RE: Sippo Creek Reservoir Dam
File Number: 0614-012
Stark County

DAM SAFETY INSPECTION REPORT

Sippo Creek Reservoir Dam

Inspection Date: May 25, 2010

Photograph No. 1:

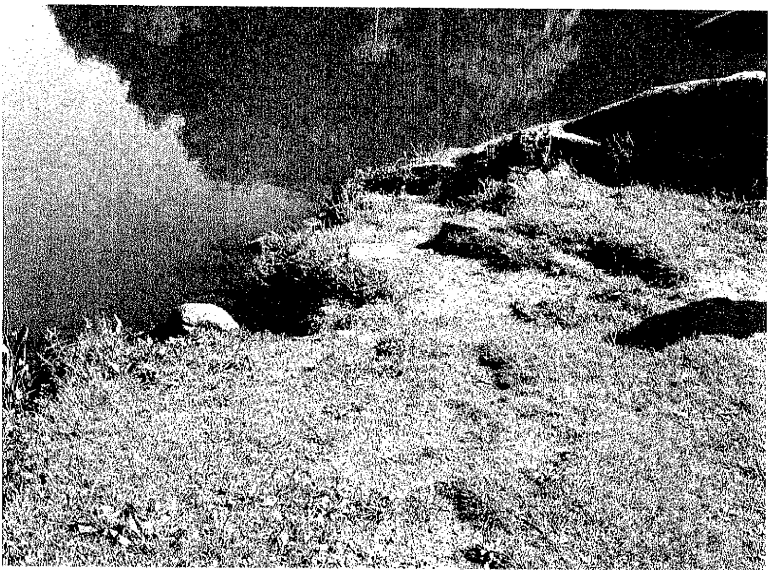
View of the upstream slope on the right half of dam. Note the trees and brush at the shore line.

2. Remove the brush from the upstream slope shoreline and around the principal spillway sidewalls. Seed all disturbed areas to establish a proper grass cover. See the "Trees and Brush" fact sheet included in this section for additional information.

Photograph No. 2:

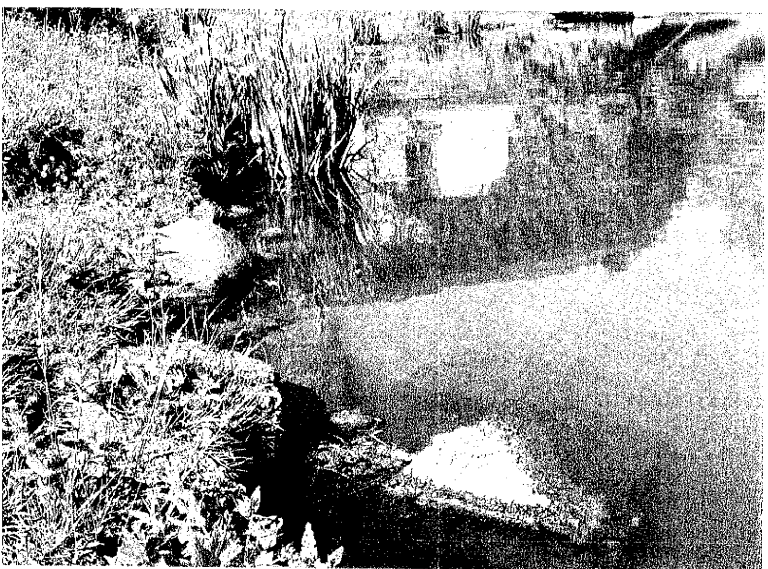
View of the erosion on the upstream slope next to the principal spillway inlet.

3. The erosion on the upstream slope of the embankment must be repaired and the upstream slope must be protected from erosion. Prepare plans and specifications for repairing the erosion and installing erosion protection.

Photograph No. 4:

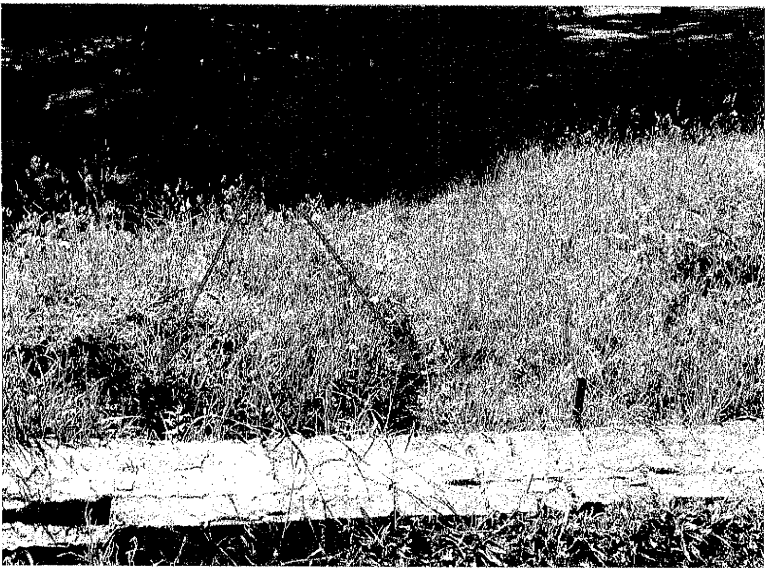
View of the crest of the dam. Note that it is much lower near the spillway.

4. The embankment crest alignment must be uniform. Investigate the vertical alignment of the crest near the principal spillway sidewalls and prepare plans and specifications for the correction of any problems. Regardless of the results of the investigation, the alignment of the crest must be monitored weekly. This item should be completed in coordination with Item 1 above.

Photograph No. 6:

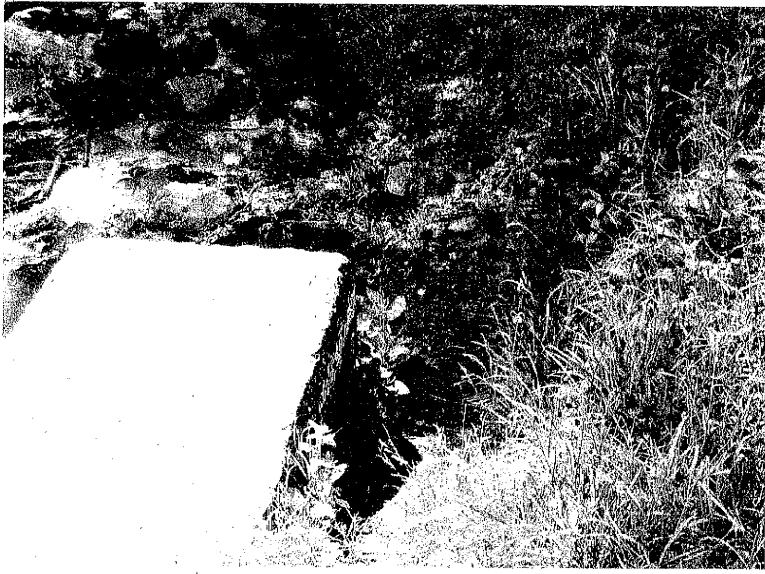
View of the right downstream slope. Again notice how much lower the crest of the dam is near the spillway.

Photograph No. 7:

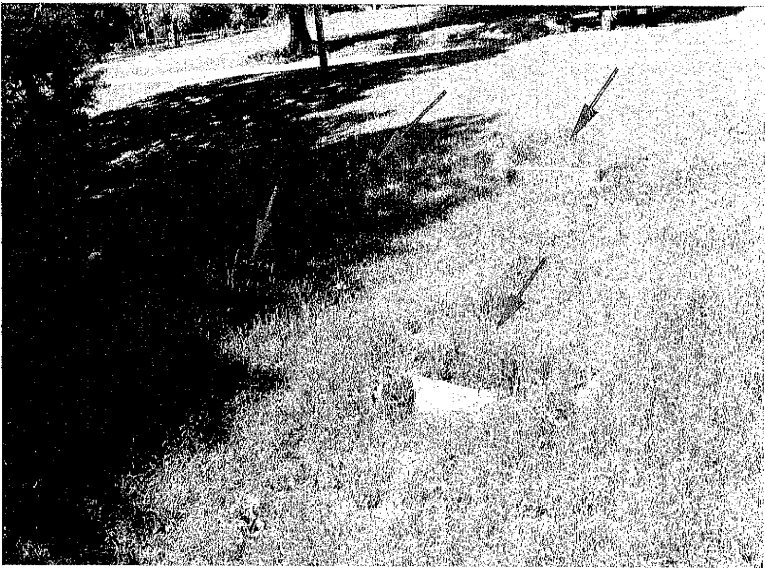
Erosion at end of slope next to spillway.

3. Repair the erosion gullies on the downstream slope, adjacent to the spillway. See the "Earth Dam Failures" fact sheet included in this section for additional information.

Photograph No. 8:

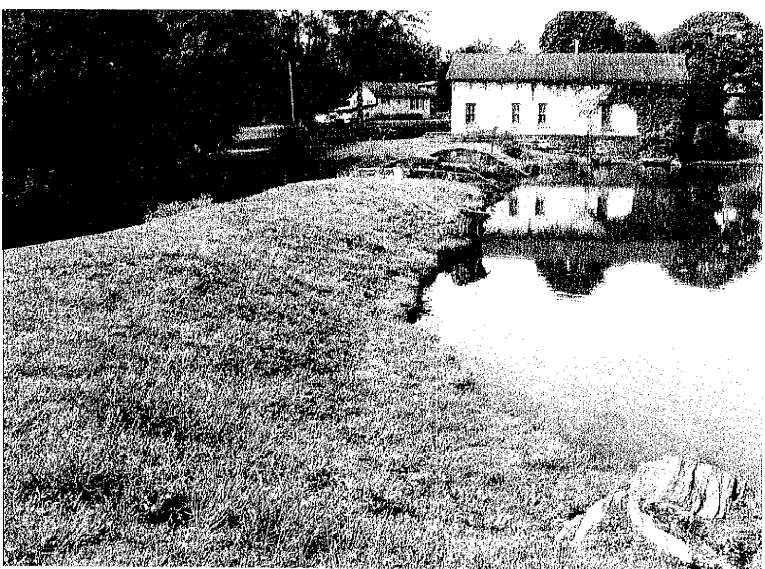
View of four flower planters on the downstream slope. They were so overgrown that they were barely visible.

6. Remove the planters on the downstream slope.

Photograph No. 12:

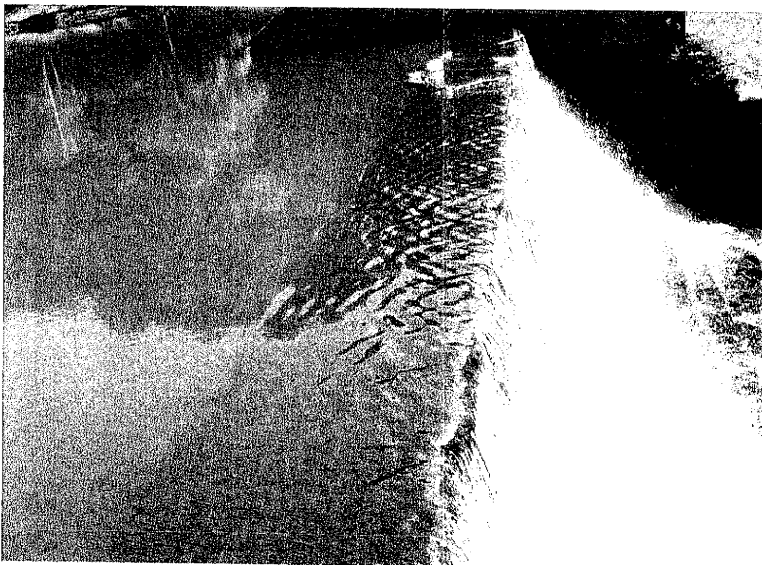
Downstream slope of left half of dam. Again note the flower planters buried in the slope.

Photograph No. 15:

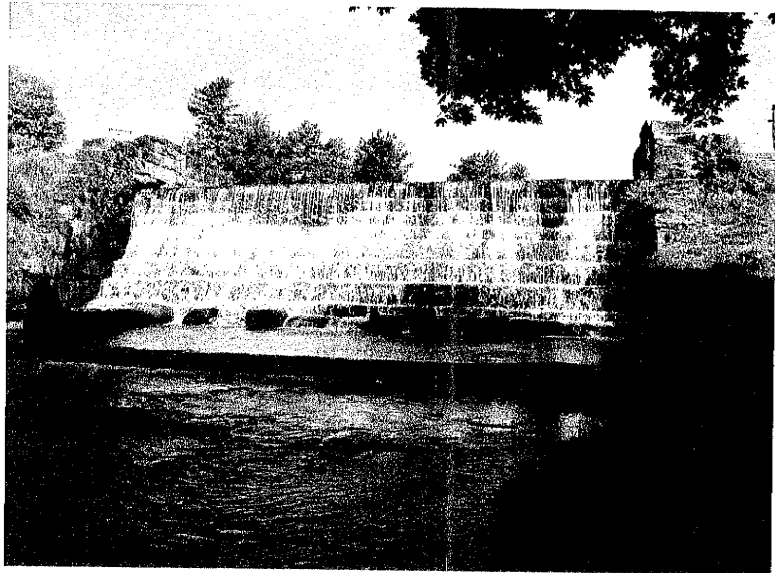
Principal spillway inlet.

Photograph No. 17:

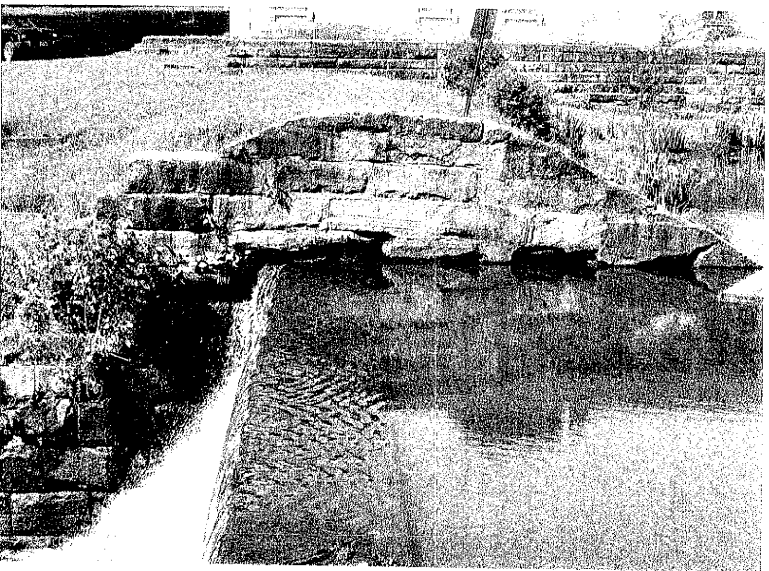
End sill of the principal spillway stilling basin. Note how weathered and worn the stone appears.

2. The spillway system must perform properly without endangering the safety of the dam. Investigate the deterioration, deformation, structural integrity, and undermining of the entire spillway system, and prepare plans and specifications for the repair or replacement of the entire spillway system. Regardless of the results of the investigation, the condition of the entire spillway system must be monitored weekly. This item should be completed in coordination with Item 1 above.

Photograph No. 18:

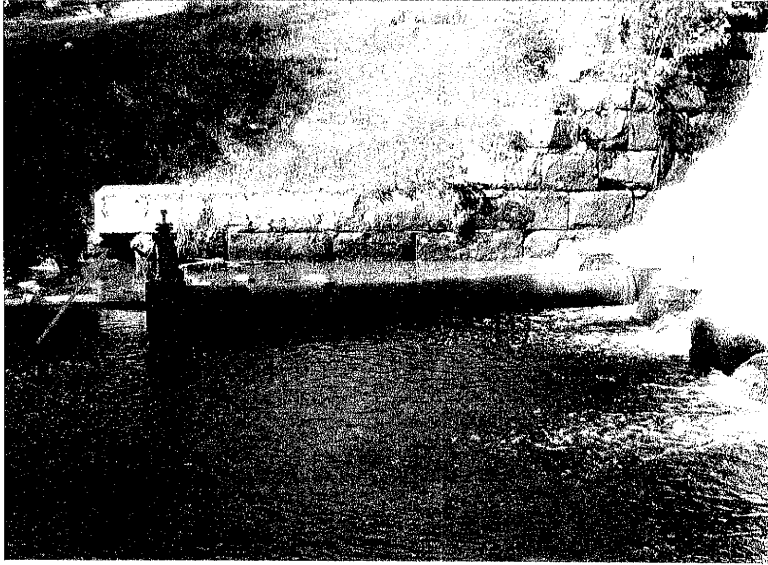
Right side wall of principal spillway. Note the undermining of the wall and the vegetation growing the cracks of the masonry.

Photograph No. 19:

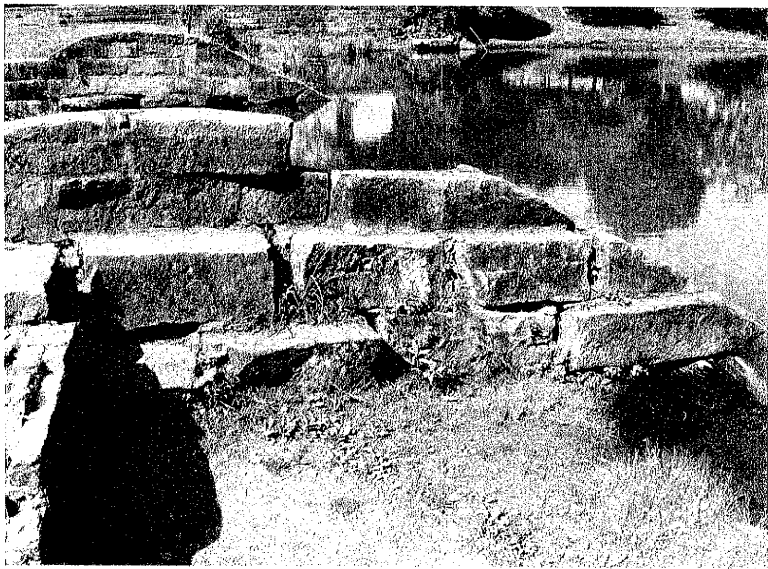
View of the lower portion of the right spillway sidewall. The arrow indicates where the water has eroded around the wall.
